Access Compliance Report Public Rights-of-Way (Curb Ramps)

Main Street: CECIL_PASTURE_RD Cross Street: CECIL_PASTURE_RD Location: E

ADA ID: RPRK211102124258 Ramp Type: Type 4 - Parallel Initial Pass/Fail: Fail Overall Compliance: No Severity Score: 2

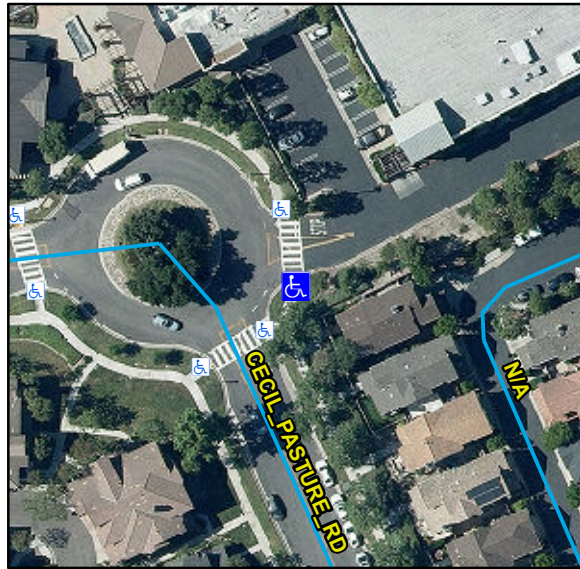
Compliance	Description	Data	Compliance	Description	Data
N/A	Ramp Length LT (in)	-9999	N/A	Ramp Length RT (in)	92
N/A	Ramp Width LT (in)	-9999	Yes	Ramp Width RT (in)	66
N/A	Ramp Run Slope LT (%)	-9999	Yes	Ramp Run Slope RT (%)	6.4
N/A	Ramp Cross Slope LT (%)	-9999	No	Ramp Cross Slope RT (%)	2.3
N/A	Landing Present	N/A	N/A	DWS Provided	N/A
N/A	Landing Length (in)	N/A	N/A	DWS Contrast	N/A
N/A	Landing Width (in)	N/A	N/A	DWS Length (in)	N/A
N/A	Landing Run Slope (%)	N/A	N/A	DWS Full Width	N/A
N/A	Landing Cross Slope (%)	N/A		DWS Offset Type	N/A
N/A	Landing Movement Obstructed?	N/A	N/A	DWS Offset Left (in)	N/A
	Landing Movement Type	N/A	N/A	DWS Offset Right (in)	N/A
N/A	Landing Shared	N/A			
N/A	Clear Space	N/A			
N/A	Clear Space To Crosswalk (in)	N/A			
N/A	Marked Crosswalk 1	Yes	N/A	Marked Crosswalk 2	N/A
	Crossing 1 Direction	N		Crossing 2 Direction	N/A
	Marked Crosswalk 1 Width (in)	144		Marked Crosswalk 2 Width (in)	N/A

N/A	Ramp Inside Crosswalk 1	Yes	N/A	Ramp Inside Crosswalk 2	N/A
	Crossing 1 Slope (%)	0.4		Crossing 2 Slope (%)	N/A
	Crossing 1 Cross Slope (%)	2.4		Crossing 2 Cross Slope (%)	N/A
N/A	Gutter Ponding	N/A	N/A	Curb Slope	9.6
Yes	Gutter Lip Height (in)	0		Road Run Slope (%)	N/A
N/A	Gutter Run Slope (%)	N/A		Road Cross Slope (%)	N/A
N/A	Gutter Cross Slope (%)	N/A	Yes	Perpendicular Joint Present	Yes
Yes	Overall Surface Condition	Acceptable			
	Cross Gutter Present?	No		Spandrel Present?	No
	Replace Cross Gutter?	N/A		Replace Spandrel?	N/A

Remove & Replace Entire Ramp.

R304.5.3, STD 1115
